# INDIANA DEPARTMENT OF TRANSPORTATION

# AGENDA

## November 17, 2023, Standards Committee Meeting

724-B-147d ALTERNATE SS JOINT (proposed to delete)

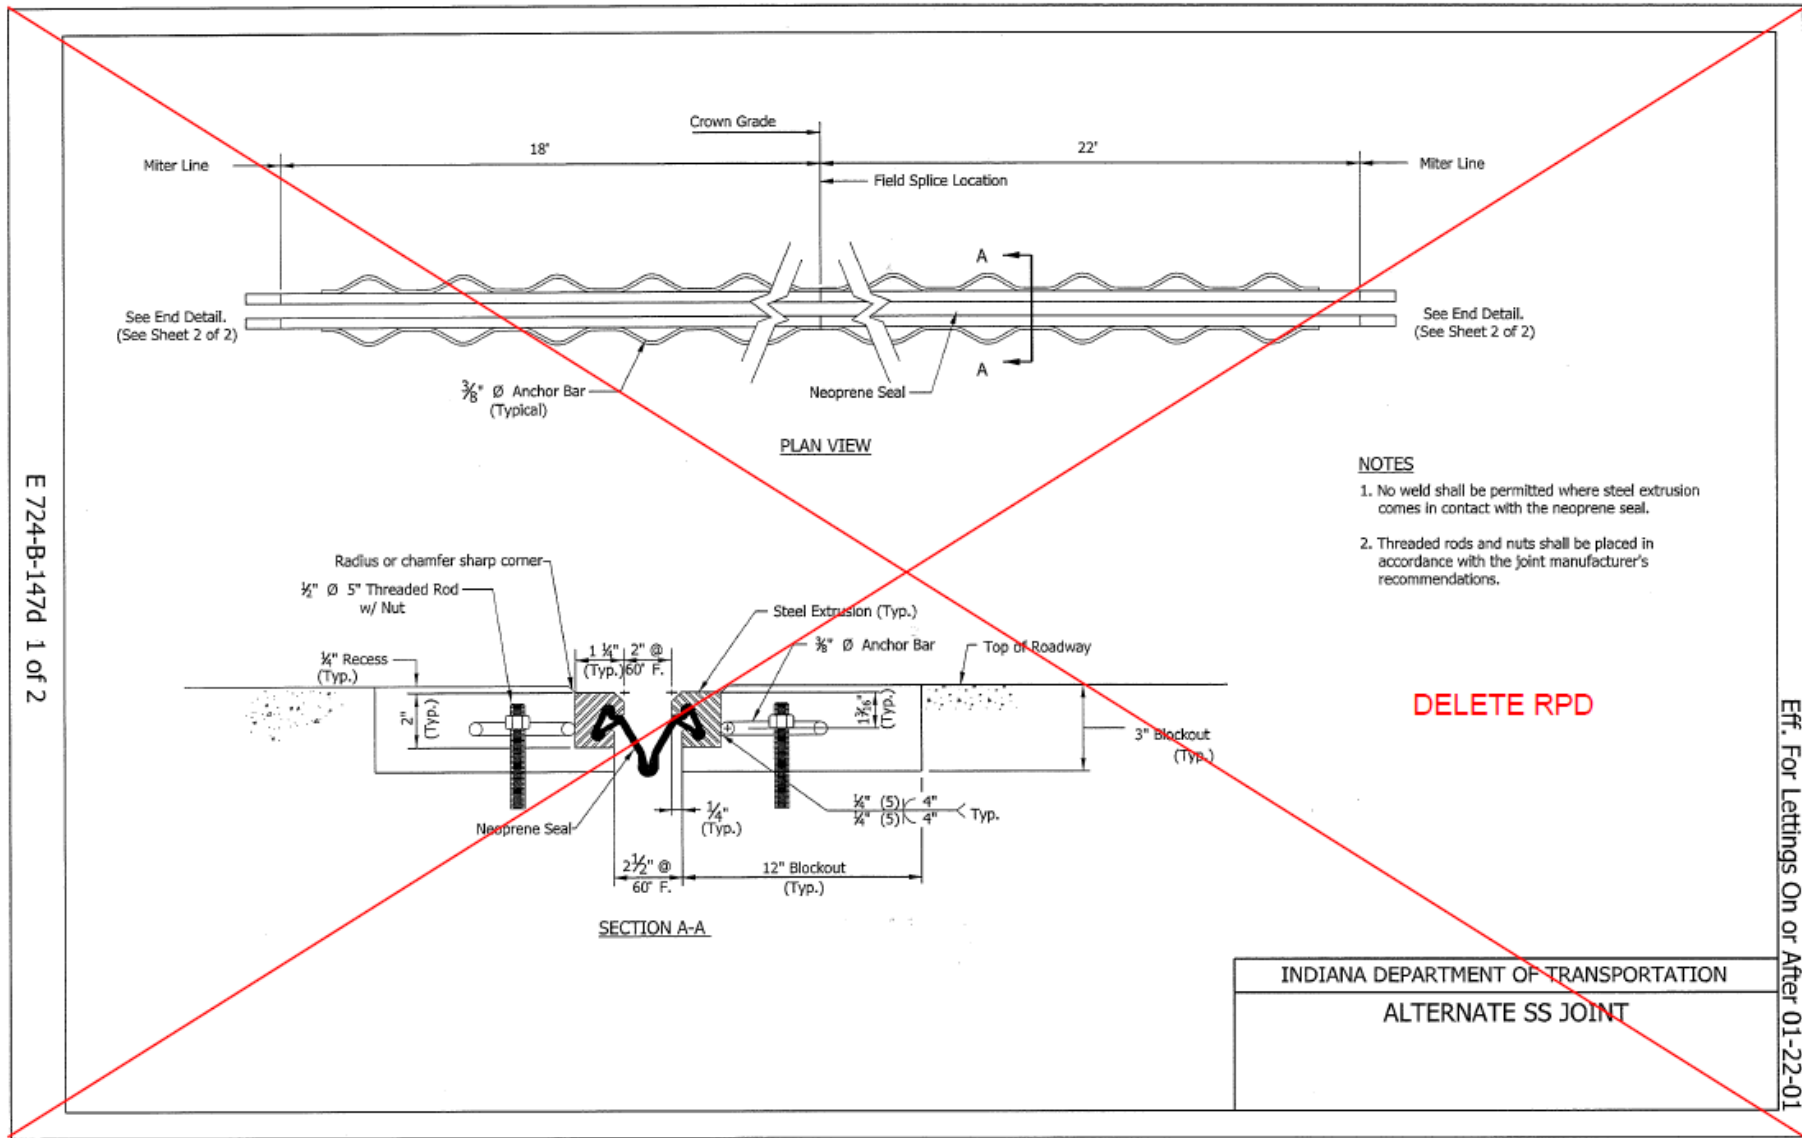
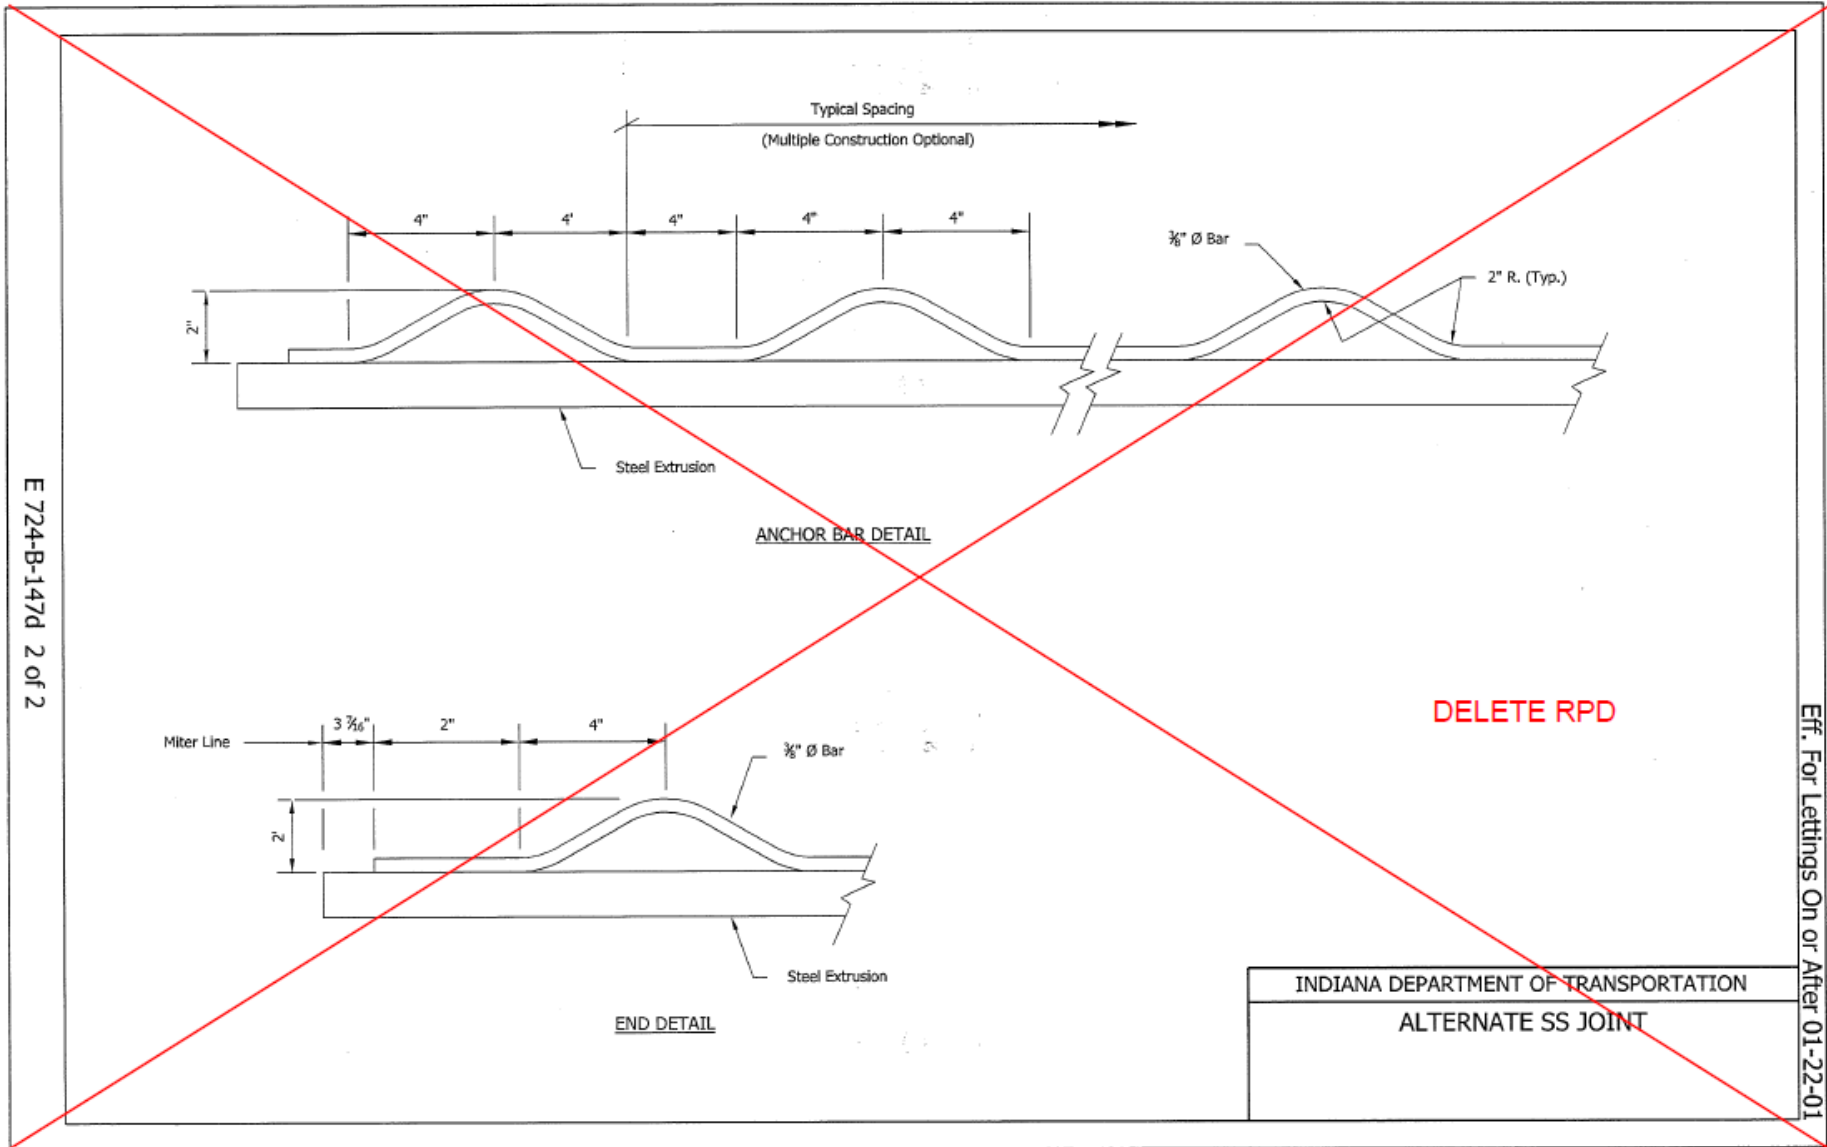
PROBLEM(S) ENCOUNTERED: The Alternate SS Joint, as shown on recurring plan detail RPD 724-B-147d, has experienced early failures at several locations.

Provide any further information as to why this proposal should be placed on the Standards Committee meeting Agenda: This joint type has proven to have a short service life and shouldn't be used on future projects.

PROPOSED SOLUTION: Eliminate RPD 724-B-147d

APPLICABLE RECURRING SPECIAL PROVISION OR PLAN DETAILS: RPD 724-B-147d, to be deleted
